CHANGE ORDER REQUEST

То	No.	COR002
Littleton Elementary School District PO Box 280,	Date	2023-02-22
Cashion, AZ 85329	Project #	210198
	Project Name	Littleton - New Elementary School at Alamar

PROPOSED CHANGE ORDER

Ths PCO reflects the added scope per the SRP Final Design and SRP Pre-con. Please see attached Marked Up SRP Plans for added scope.

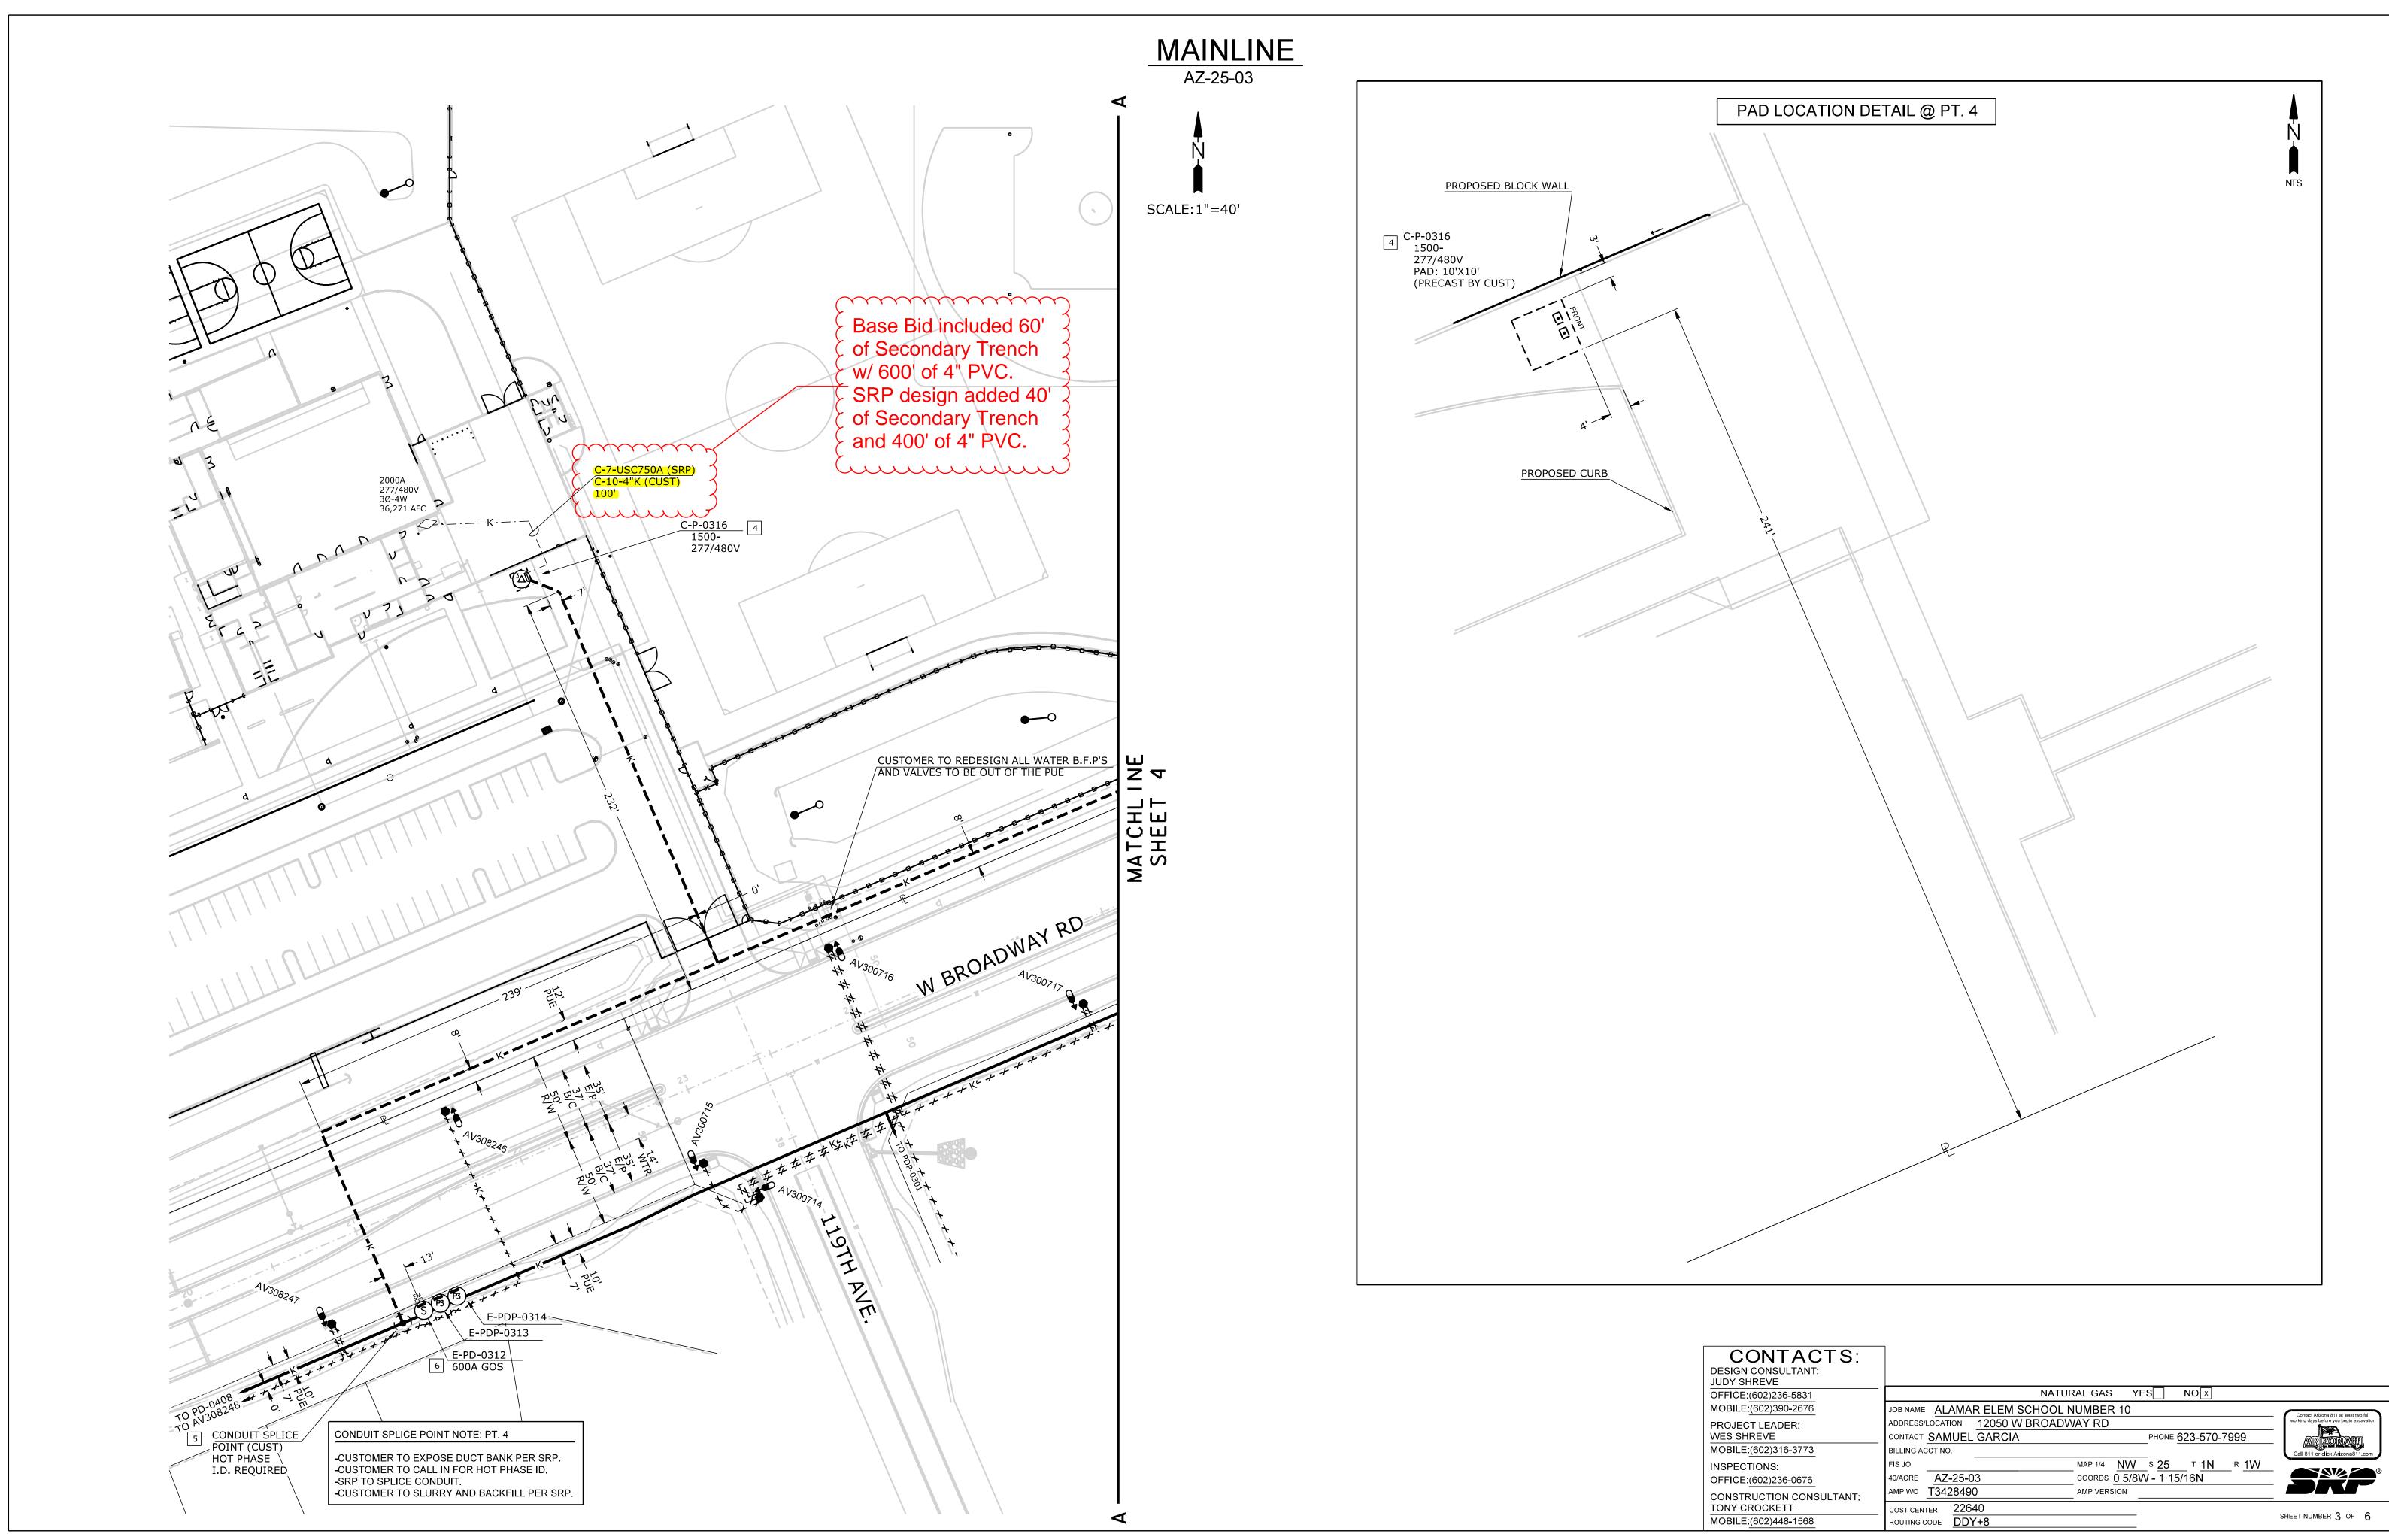
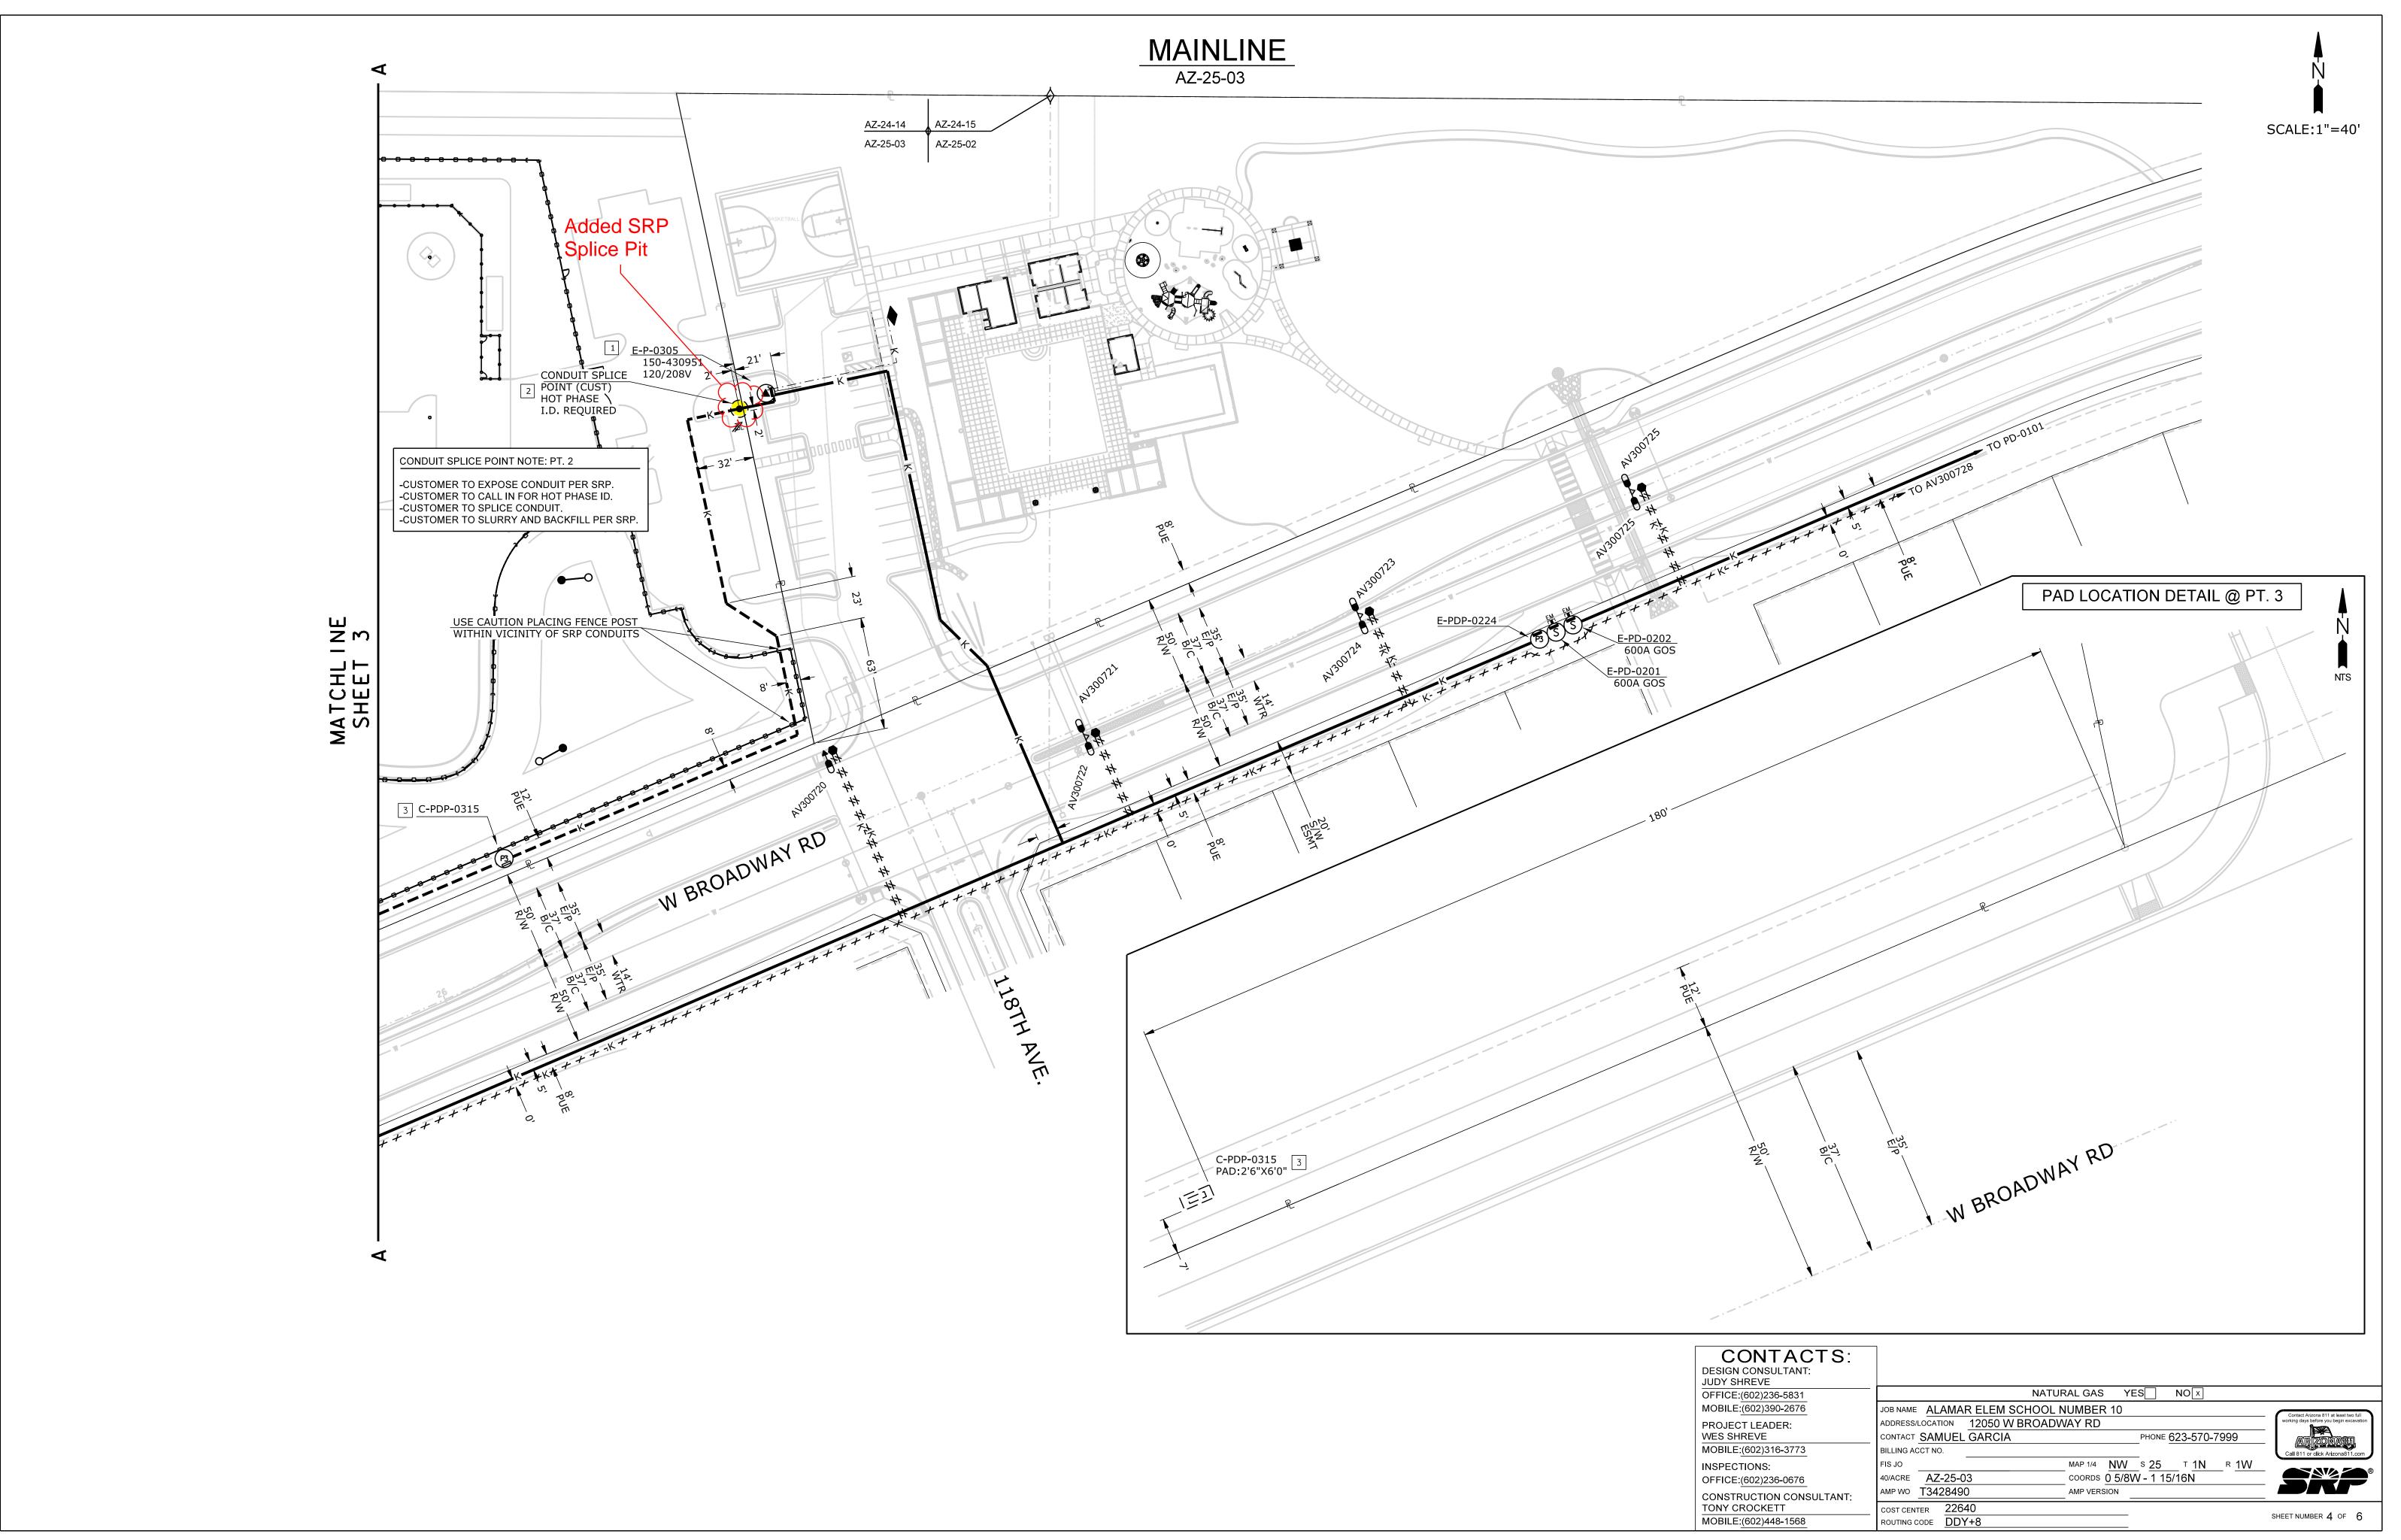
Added Scope breakdown as follows:

Added Secondary Trench & Conduit per SRP Design - \$8,904.40 electrical

Added (Street Crossing) Boring - \$17,777.85 electrical

Added (Street Crossing) Splice Pits - \$10,808.52 electrical

Added (Street Crossing) Potholing - \$5,521.17 Survey

Added (Street Crossing) Traffic Control - \$15,000.00 electrical

Added Pulling Enclosure - \$6,184.92 electrical

Added Existing Duct Bank Tie-in - \$4,500.00 electrical
